**From:** Warrior, Andrew  
**Sent:** 20 February 2020 14:13  
**To:** Kelsey Blain  
**Subject:** RE: Listed Building Consent and Planning Application for Mount Misery Farm, Hackness

Project  
Mount Misery Farm

Content  
Casement Window Details and Sections

Content  
Yorkshire Light Window Details and Sections

Rev	Description	Dn	Chk	Date

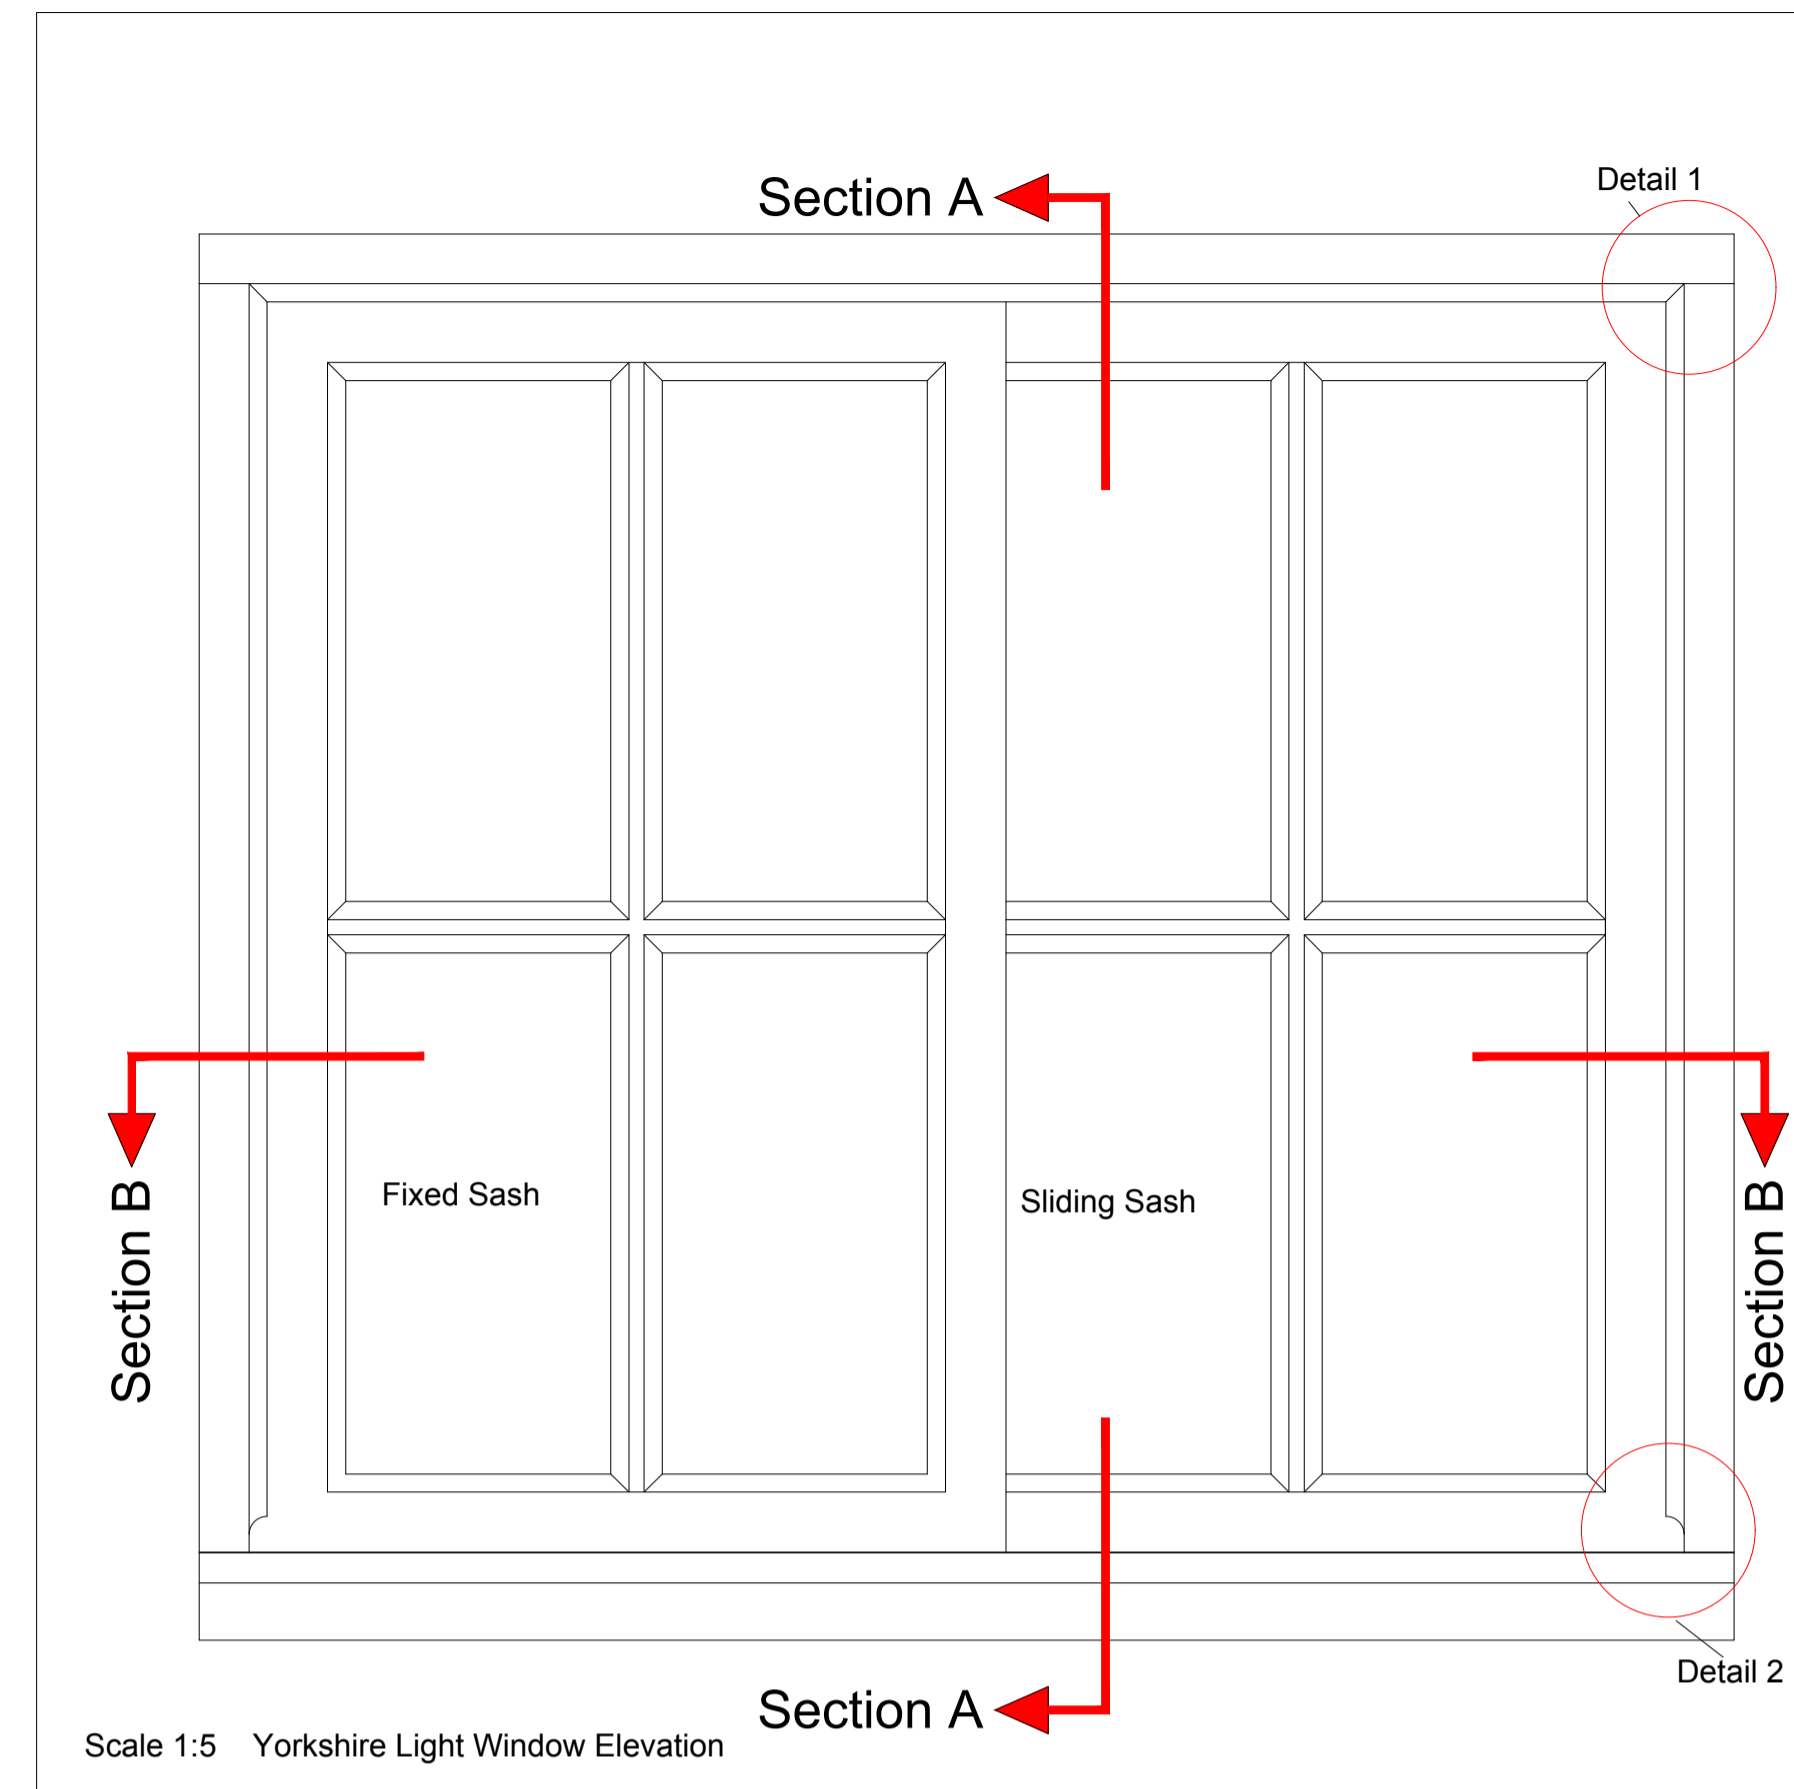
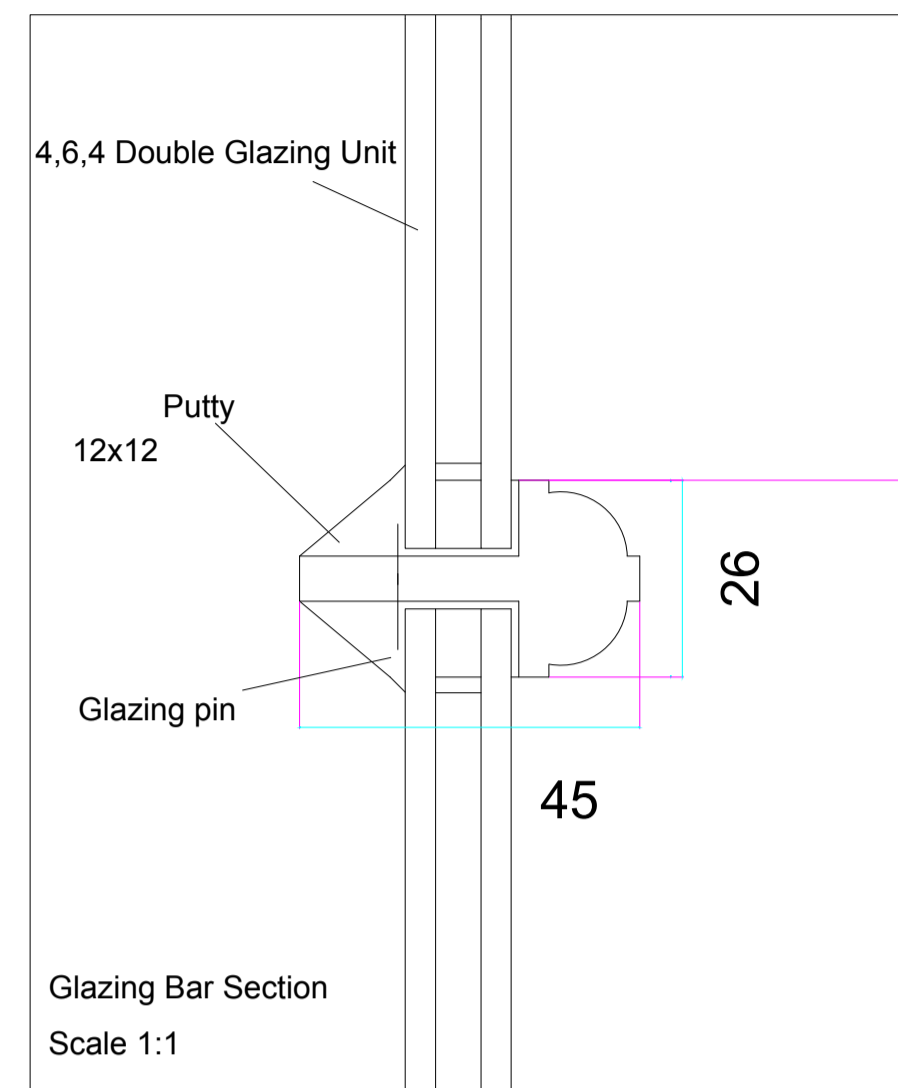
Yorkshire s/s

- Glazing to be putty pointed, not beads as mentioned above.

- Reduction in size of glazing bar, 22mm if possible?

- Could consideration be given to use of a leaded cill, rather than a projecting cill – see example attached

Although timber beading would be more suitable for double glazed units and the profile would look like putty as the timber beading in the photo you provided I would be able to specify putty

As we are fitting double glazed units it would not be possible to reduce the size of the glazing bars. The double glazed unit spacing bar has a depth of 10mm, the rebate and the glass should have a 2mm clearance this is why the rebate depth has to be 12mm. When fitting beads to hold the unit in place the feather has to be sufficient to provide a secure fixing for the pins as you have requested putty the thickness of the feather is crucial to provide a safe and secure fixings.

The projecting cill is preferred as it will allow water to drain away from the building and prevent the water from traveling back in to the building by capillary action.

The sliding sash to the Yorkshire light will be secured by a fitch fastener.
